THE ANSI/ANS STANDARD 58.2-1988: TWO-PHASE JET MODEL

Graham Wallis September 15, 2004

This memo critiques the methods described in the Standard, compares them with the referenced technical models and the probable reality, and also with independent calculations. The work has been performed quickly in order to

Figure 1 Pressure contours for a jet issuing between two discs⁴

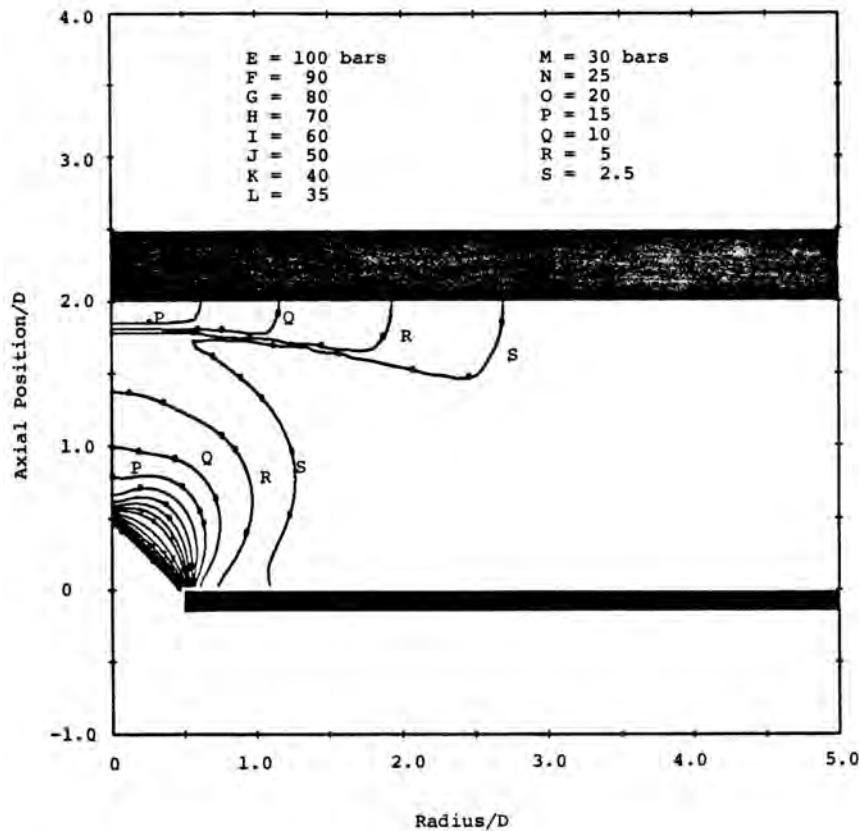
Figure 1 shows a "core" region in which there is no depressurization, rather than the usual situation where choking occurs at the exit plane. This may be a real effect as there is evidence from the Marviken tests of a region near the break where the stagnation pressure is fully recoverable; it doesn't matter for the far field at large distances from the break.

The jet is able to turn 90° and follow the inner wall, executing the familiar Prandtl-Meyer expansion. The contours of constant pressure near the nozzle resemble those from a point source to some extent.

Figure 2 Velocity vectors corresponding to Figure 1

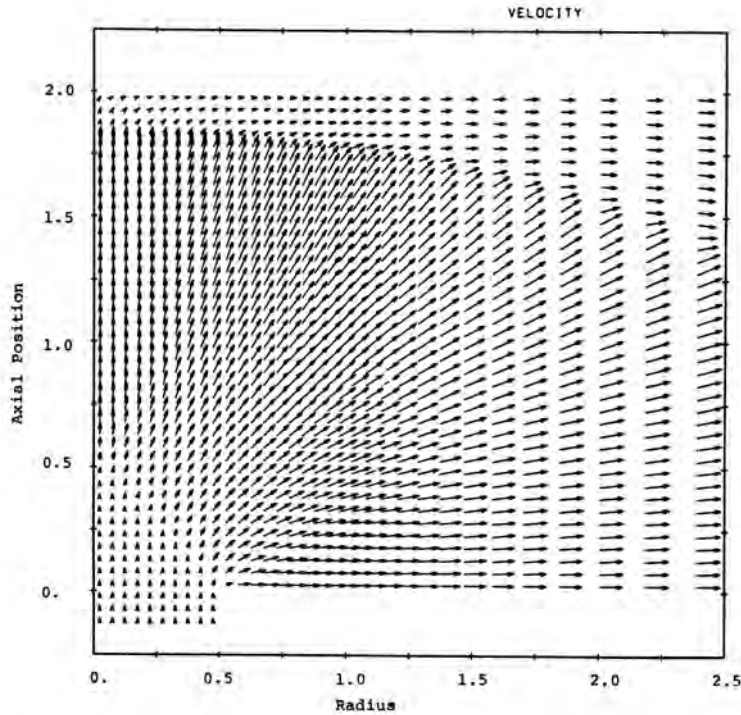
Figure 2 shows the corresponding velocity vectors. The supersonic flow undergoes a shock as it approaches the target plate. The shock is normal near the stagnation point and oblique further out. The calculation is not

continued to the "outside world" at large radius, but presumably there would have to be another shock wave to enable the flow to get out of the disc-like slot into an atmosphere at 1bar.

These two problems are quite different. This is shown clearly by the velocity vectors in Figure 2. The only region where the two flow fields are the same is in a small region close to the nozzle that is unaffected by waves

Figure 3 Pressure distribution along the target plate⁴

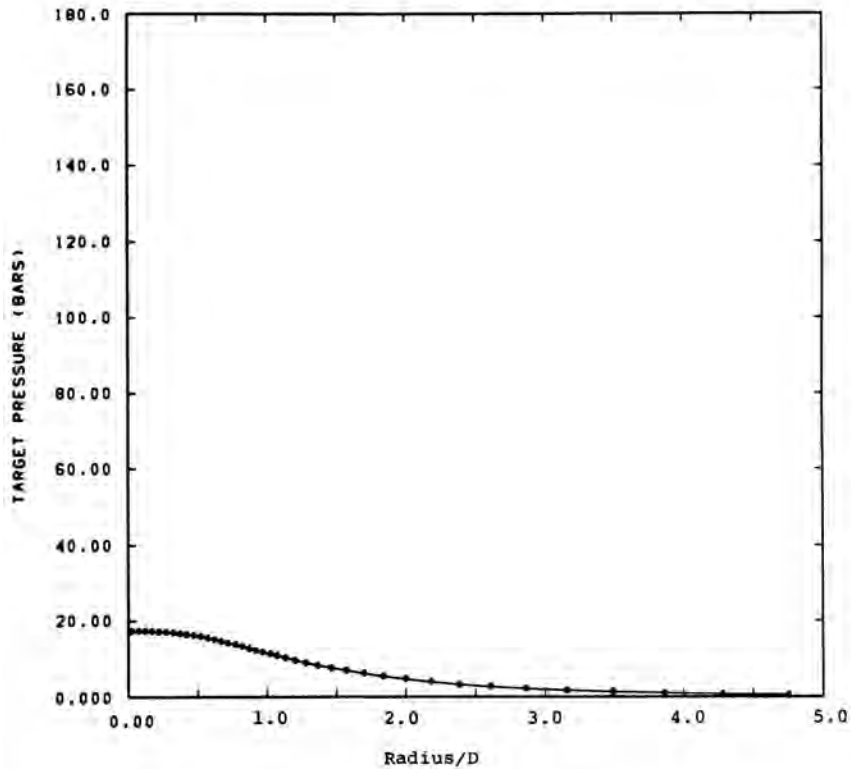
Figure 3 shows the pressure distribution on the large target disc. The pressure is seen to fall off with radius. Since the flow is inviscid in this model, the streamlines from the stagnation point flow along the surface, conserving stagnation pressure. This would be the maximum pressure felt by an object placed anywhere close to the target surface and it would be the same at all radii. For example, at $R/D = 2$, the static pressure on the target plate is about 5bar, but an object near the plate would experience the full stagnation pressure of 18bar.

Figure 4 Jet model in the ANSI/ANS Standard

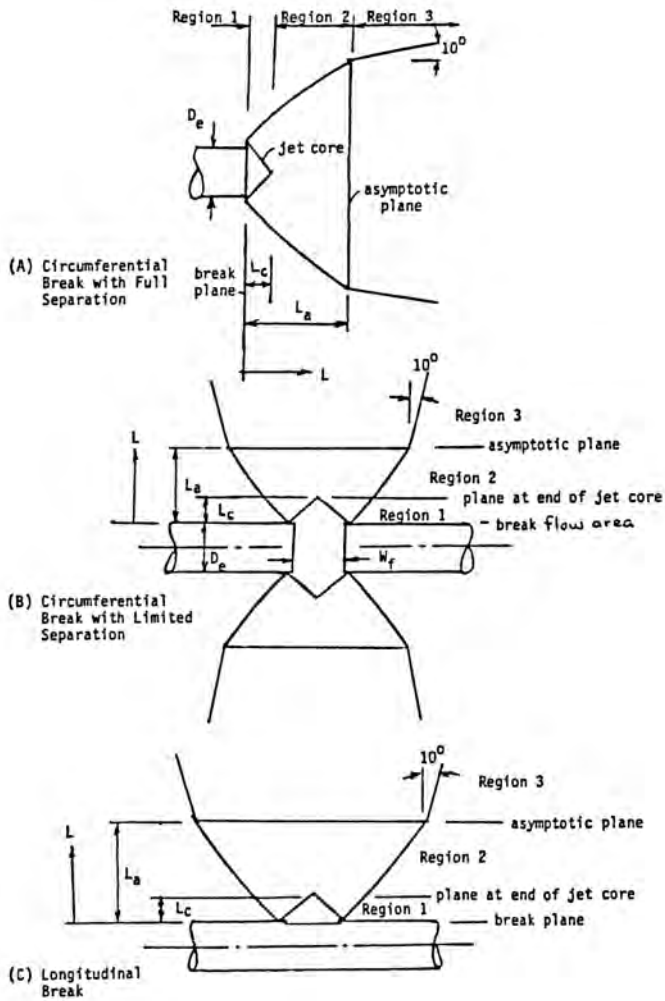
Region 2 follows the 45° cone assumed by Sandia. It ends at an "asymptotic area". For low subcooling this is where the pressure is predicted to be atmospheric. The area, A_a of the jet at this plane is computed from

In Region 3, "interaction with the surrounding environment is assumed to start" and the jet is then assumed to expand with a 10 degree exterior half-angle after the "asymptotic plane". There is no discussion of shock waves forming in front of obstacles. The assumption seems to be that all supersonic effects are over at the end of Region 2 and the jet behavior is thereafter governed by turbulent mixing with the surrounding fluid.

The concept that supersonic expansion stops at an "asymptotic plane" is not consistent with observation. In the Marviken tests, and according to theory, the mean pressure in the jet reaches ambient pressure at dimensionless distances from the nozzle, L/D_e or z/D_c , between 1 and 2. Figure 5 shows a schlieren photo of a supersonic jet expanding with about the same pressure ratio, p_0/p_a , as at the start of a LOCA. The jet expands for about 7 L/D then begins to contract and passes through a shock wave at around 10 L/D (it is unclear what the inside diameter of the pipe was). At much lower pressure ratios, as in the later stages of a LOCA, the jet initially expands much less, but it then passes through several shock diamonds, again out to around $L/D \sim 10$ (Figure 6).

The ANSI/ANS approach that all is over at an "asymptotic plane" at the end of Region 2, around L/D =1.5 or 2, does not seem to correspond to reality. Continued expansion at a half-angle of 10 degrees in Region 3 also appears to have no clear justification and may predict too low an impact pressure at high L/Ds. It would perhaps be desirable to make suitable CFD predictions, and compare with experimental results, for longer L/Ds than have been used so far.

Figure 7 Characteristics net used in reference 2

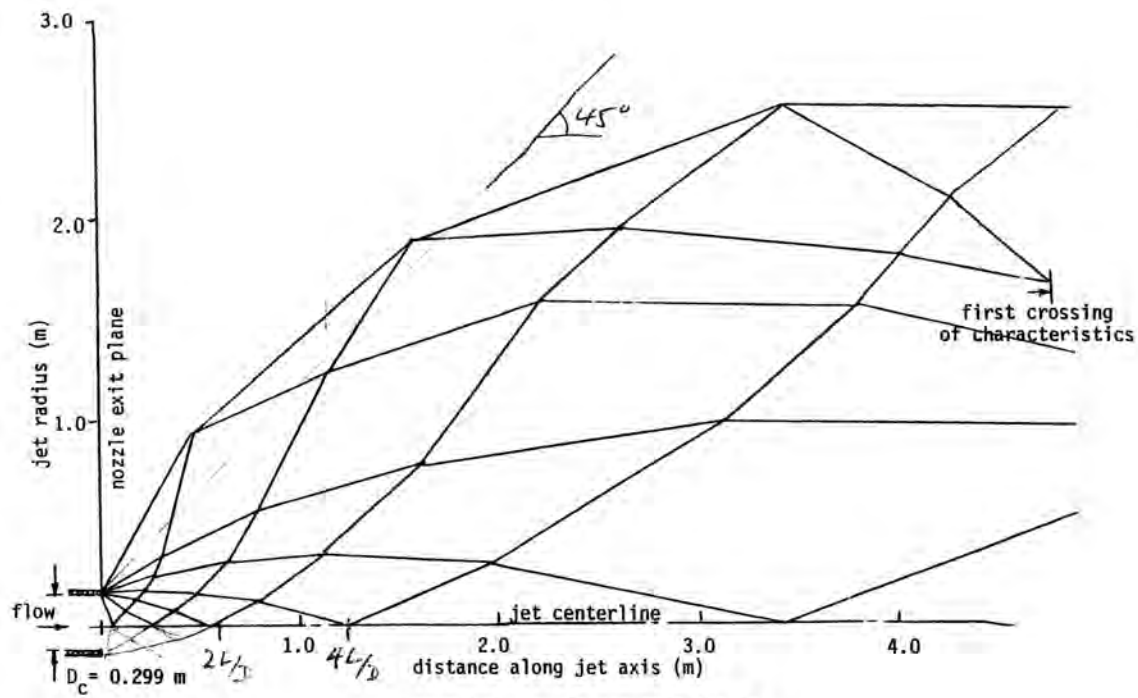
An expanding free two-phase steam-water jet is analyzed in EPRI NP-4362² using the method of characteristics. Figure 7 shows a typical characteristics net from that report. It can be seen to capture several of the features shown in Figure 5. Expansion of the jet continues to L/D about 12 before the envelope begins to contract.

At atmospheric pressure the jet is predicted to have expanded to a radius of $0.299 \times 4.25/2 = 0.635\text{m}$. To compare with Figure 3-4 from reference 2 we need to account for the angle of the jet surface, where the axial component of velocity is only about 1/2 of the net speed. Then the mean jet pressure might be about atmospheric at somewhere near $2 L/D_e$, a little farther than would be predicted from the one-dimensional assumption (C-5), $1.625 L/D_e$, that defines the end of Region 2 in the ANS standard. Figures 4-2 and 4-3 of reference 2 show the pressure on the axis reaching ambient from $L/D_c = 1.5$ to 2, depending on the upstream stagnation conditions. Apparently, the ANSI/ANS standard provides a reasonable approximation. The pressure then drops below ambient, recovering to ambient at around $L/D_c = 7$. In reference 2 the calculations appear to have been carried out to about $L/D_c = 10$. In the earlier publication³, including some of the same authors, the characteristics net appeared to terminate at $z/D = 3$, in most cases.

At $L/D_e = 4$ in Figure 3-4 the jet radius is about 1.5m, or $D/D_e = 10$. This would correspond in Table 1 to a mean pressure of about 0.015MPa. Since the outside of the jet is still at 0.1MPa, if the ambient pressure is 1bar, it would appear that the centerline must be at an even lower pressure than the average value, perhaps around 0.01MPa. This occurs because expansion waves keep arriving on the axis from both sides. Similarly, at $L=1.7\text{m}$, $L/D_e=5.7$, the jet radius is 2m, $D/D_e=13.3$ and the average jet pressure is below 0.01MPa while at $L=3.5\text{m}$, $D/D_e=16.7$ and the average pressure is

After a distance of 4m the jet begins to contract. Some of the characteristics cross, indicating the formation of shock waves. If these are weak, the jet will collapse to conditions resembling those close to the nozzle, in the absence of other dissipative effects, as compression waves reflected from the free surface recompress the fluid. Then the impact pressures on targets will increase with distance from the nozzle. However, it appears from Figures 5 and 7, that there will be a normal shock at about $L/D = 16$ which will limit further significant refocusing of the jet energy and momentum.
